City of Alexandria, Virginia

MEMORANDUM

SUBJECT: RECEIPT OF REPORT ON THE WOODROW WILSON BRIDGE PROJECT PLANS FOR JONES POINT PARK AND THE URBAN DECK AND SETTING THE REPORT FOR PUBLIC HEARING ON SATURDAY, NOVEMBER 18 AND COUNCIL CONSIDERATION ON TUESDAY, DECEMBER 12

ISSUE: Receipt of report on the Woodrow Wilson Bridge project plans for Jones Point Park and the Urban Deck

Site Plan

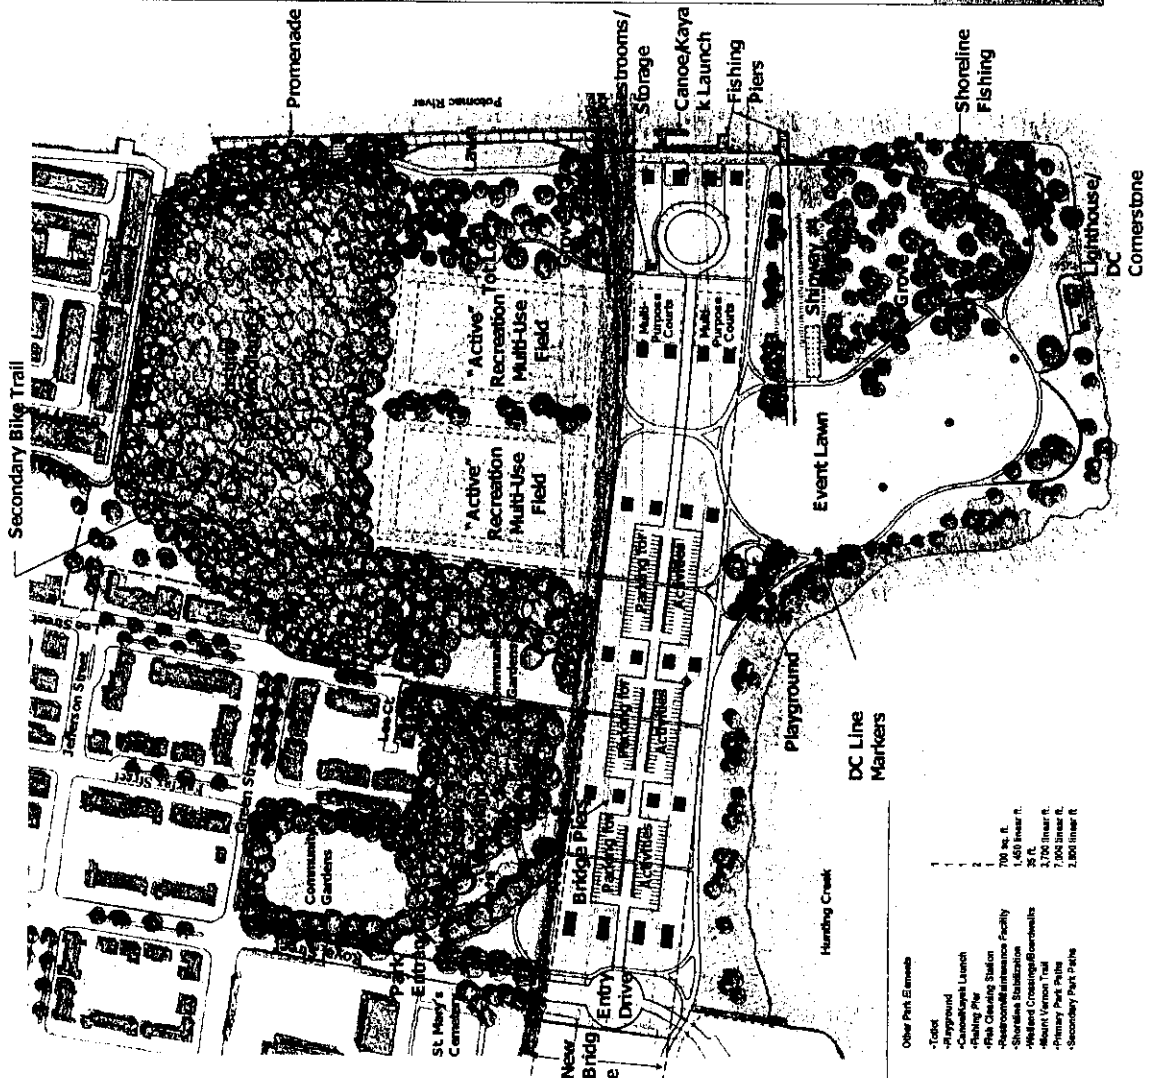
Staff does not support changing the proposed plan in this way. With respect to the athletic fields, a goal of the plan, as noted above and supported by the Park and Recreation Commission, is to separate active and passive recreation by keeping passive activities to the south of the bridge and active recreation on the north side. There are approximately 21 acres of woodland north of the new bridge. Under the plan, approximately four acres of woodlands will be cleared. Studies conducted on the north side show that only nine trees with a caliper of 24 inches or more will be removed, and of these nine trees, two are in poor health. Because this area was originally a fill site for river spoils

Since the 30% design, additional studies have been performed on existing natural and cultural resources. The Jones Point Stakeholder Participation Panel indicated a strong desire to preserve the larger native trees in the southern portion, which could limit the size and location of the community gathering space. As presently proposed in the 65% design plan, only .65 acres of woodlands will be removed for shipway interpretation. Within those .65 acres, there are three trees with a caliper of 24 inches or more. Existing trees will be limbed up to allow views of the water from most areas of the park and increase the openness of the space for passive recreational use and the City birthday celebration. Since almost all of the trees are being preserved, the amount of community gathering space is smaller than originally planned.

As shown in Attachment 1, the plan proposes two bicycle trails through the park: a) the primary Mt. Vernon Bike Trail which is on the north side of the bridge runs through the park along the eastern (river) side and then turns west under the bridge to Royal Street, and b) the secondary bike trail in the northern/central section of the Park runs through the wooded area, along the western side of the playing fields and connects with the primary Bike Trail under the bridge.

Staff supports the secondary bike trail for the same reasons the Park and Recreation Commission and the Bicycle Study Committee do: a) it allows faster cyclists to use the secondary path and slower cyclists to use the riverside path, thereby reducing potential conflicts between walkers and cyclists traveling at fast speeds, b) it allows more people to use the central part of the park which will increase safety, and c) it gives the Police the ability to patrol the wooded area. In addition, staff believes the impact to trees and wetlands will be minimal. As part of the 90% plans, staff will incorporate designs sensitive to trees and wetlands.

Interim Park Improvements Plan

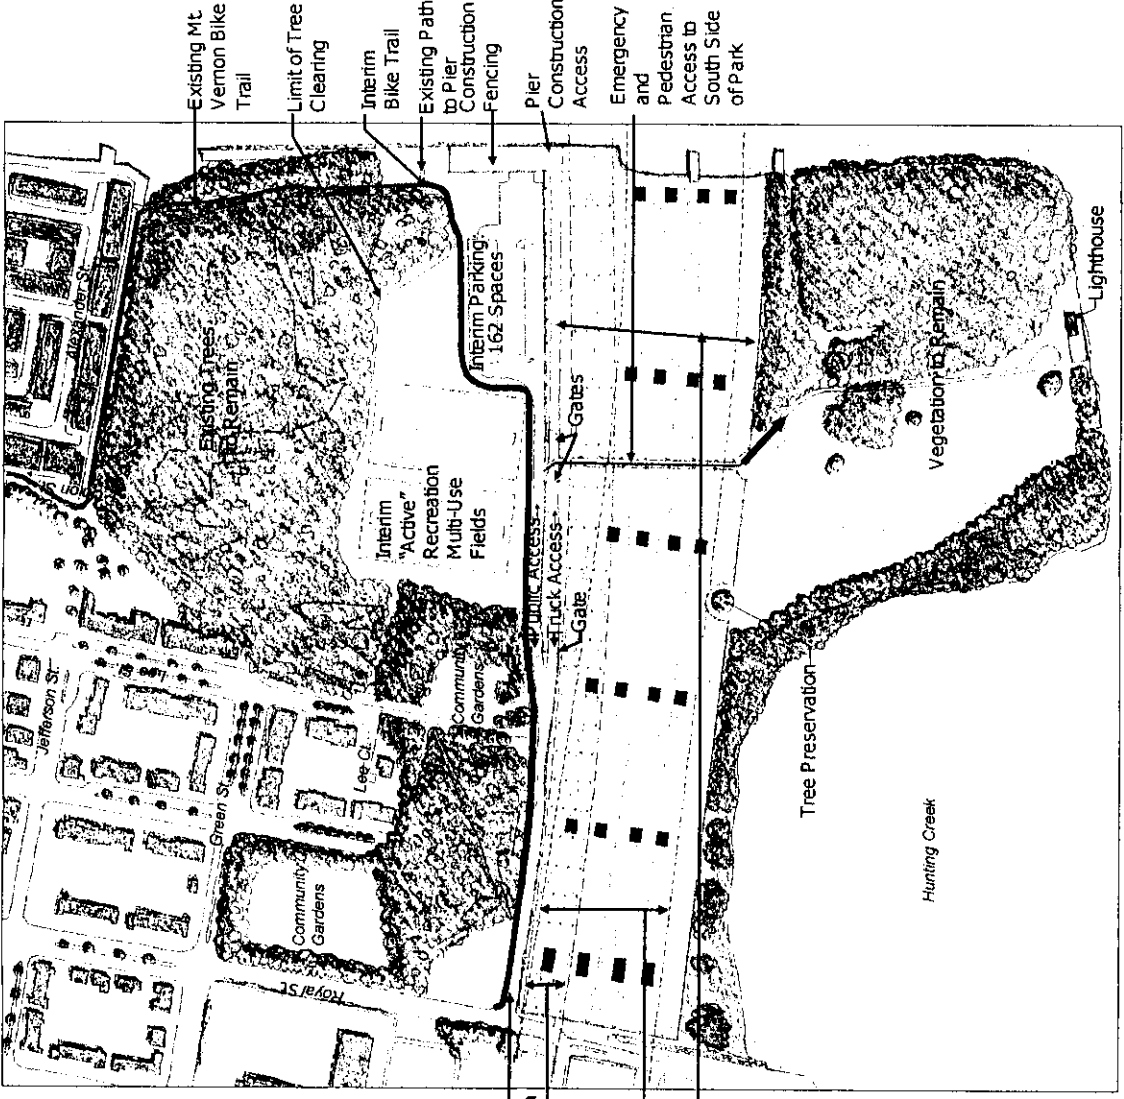
7. We are particularly pleased that the interim plans include keeping the Mt. Vernon trail segment open during construction. If closing of the interim path is necessary during construction, it should not be closed without there first being a route planned and marked to use as an alternative during the closure periods. Further, we recommend that the interim trail work include repair to the tree root and other damage to the path from where it turns south at Ford's Landing to where it joins the current park road. This segment of the path is in no condition to last until a new trail is built.

Urban Deck
Location Map

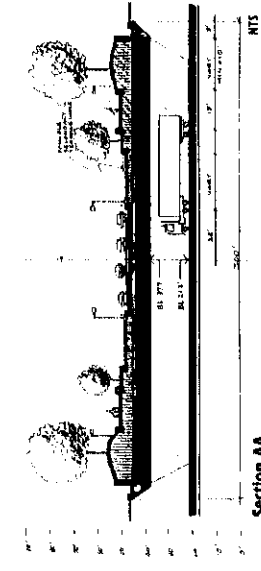
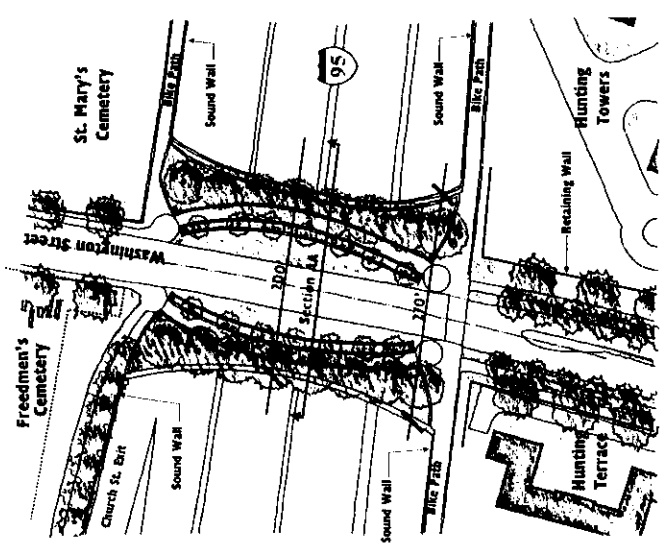
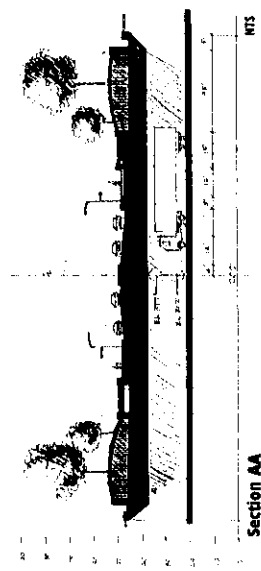
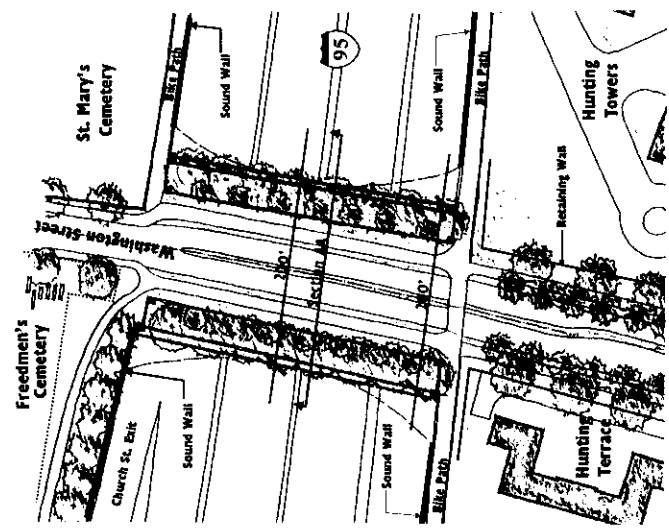
The Park and Recreation Commission and the Waterfront Committee support the smaller deck provided the following issues are addressed: noise and air quality studies show no greater impact on neighbors (noise and air quality are discussed below); recreation fields in the R.O.D. and the settlement agreement are located elsewhere (the City is pursuing this); curvilinear design is favored with a larger deck designed on the east side of Washington Street to provide greater enjoyment by the users of the trail over the bridge; and consideration be given for bas relief sculptures depicting historic events in Alexandria on the sound walls at the southern entrance to the City (staff will discuss with Potomac Crossing Consultants).

Friends of Freedmen’s Cemetery supports a deck which extends to the maximum possible distance to the east and west and the least possible distance to the north and south, while supporting passive recreation and reducing the noise and visual intrusion of the Beltway. The Environmental Policy Commission supports the “Streetscape” concept and suggests the Urban Deck be planted with native trees and other native vegetation to enhance the value of the deck for passive recreation and as a quality wildlife habitat.

6. We are pleased to see the multi-use path from the Rt. 1 interchange connection to the Urban Deck. While we recognize that the Urban Deck drawings are very preliminary, we do want to note that they do not show a multi-use path design that is friendly to through bike or rollerblade traffic. Several comments apply: the turning angles need to be considerably less severe; if the connection to the bridge is going to be through the minimum deck design, consider widening the east side of the deck somewhat to accommodate the multi-use path; if the Mt. Vernon Path could be realigned along the river, the connection from the Rt. 1 path for cyclists may be able to be aligned to coincide with the light at the Hunting Terrace intersection. Pedestrian traffic going into Old Town from the Rt. 1 area should still be routed directly up to the urban deck (to minimize pedestrian travel distances), to cross the urban deck on the west to the light at Church St. If these configurations are not possible, a pedestrian/bicycle activated light would be an absolute necessity to cross Washington St. just south of the Urban Deck.
